# UNITED STATES PATENT AND TRADEMARK OFFICE

APPLICATION NO.	FILING DATE	FIRST NAMED INVENTOR	ATTORNEY DOCKET NO.	CONFIRMATION NO.
10/687,481	10/15/2003	Yu-Jiun Wang		8931

<b>Office Action Summary</b>	<b>Application No.</b> 10/687,481	<b>Applicant(s)</b> WANG ET AL.	
	<b>Examiner</b> Timothy M. Ayres	<b>Art Unit</b> 3637

### **DETAILED ACTION**

Klakovich ('768) Fig. 7

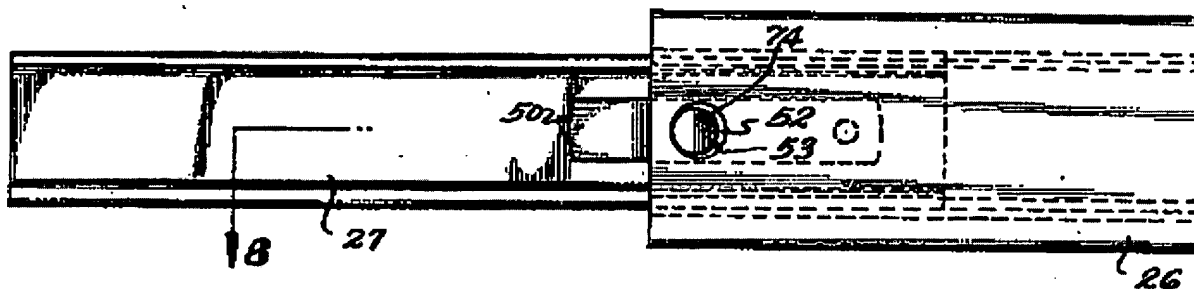
5. Claims 1-3, 5-11, and 13-16 are rejected under 35 U.S.C. 102(b) as being clearly anticipated by U.S. Patent 3,133,768 to Klakovich. Klakovich ('768) discloses a rail assembly (22) used to support electronic components. A rail bracket (25, 29) is fixed to a sidewall of a cabinet. An outer rail (26) is movable to the rail bracket (25, 29). An inner rail (27) is movably received in the Outer rail (26). A blocking member (53) on the outer rail (26) and engages with an acting member (52) to cause concurrent movement of the inner rail (27) and the outer rail (26) (Col. 4, line 3-14; Col.3, line 51-62).

Klakovich ('768) Fig. 4

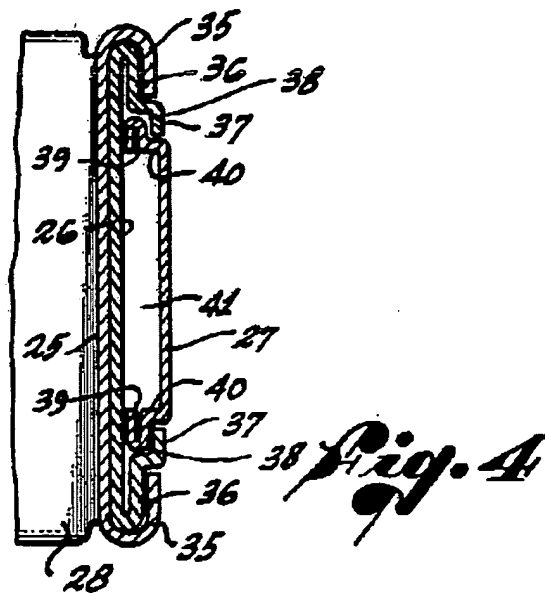
The inner rail (27) has flanges (39) that fit into guiding portions (38), which are created on the outer rail (26) with lip (37). Railings (36) of the outer rail (26) slide in guiding portion (35) of the rail bracket (25). The inner rail (27) and the outer rail (26) have base plates that are the straight portions defined on both sides of the gap (41).

Klakovich ('768) Fig. 2

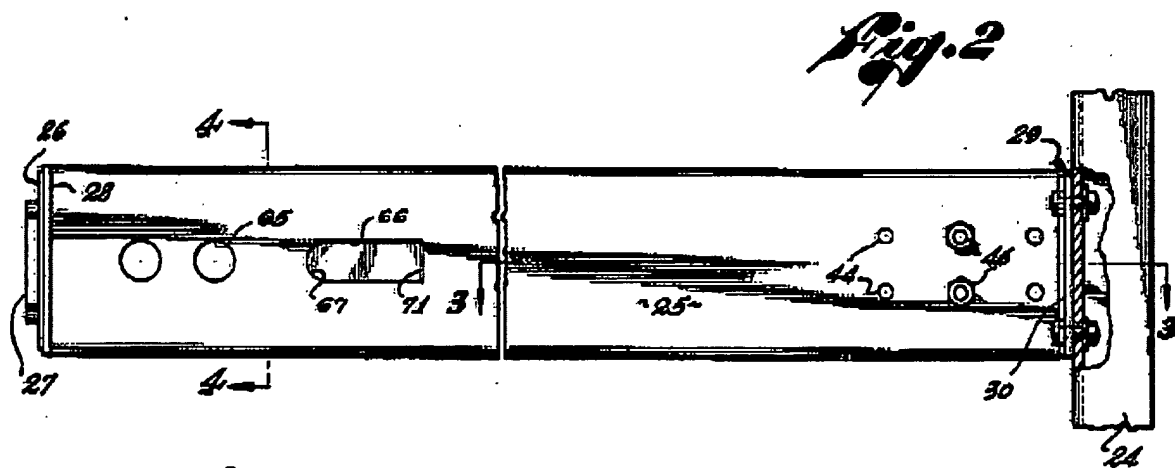
The rail bracket assembly includes a first part (25) that includes an adjustable bracket (29) that mounts to a cabinet. The bracket (29) is adjustably connected with multiple holes (44) and bolts (46) to the first part (25).

Klakovich ('768) Fig. 9

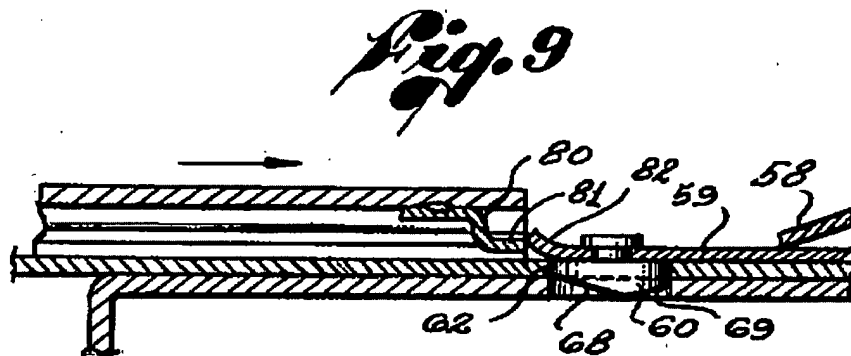
The rail assembly includes plate (59) attached to outer rail (26), which abuts to the tab (81) that is attached on inner rail (27) and prevent movement between the inner rail (27) and the outer rail (26).
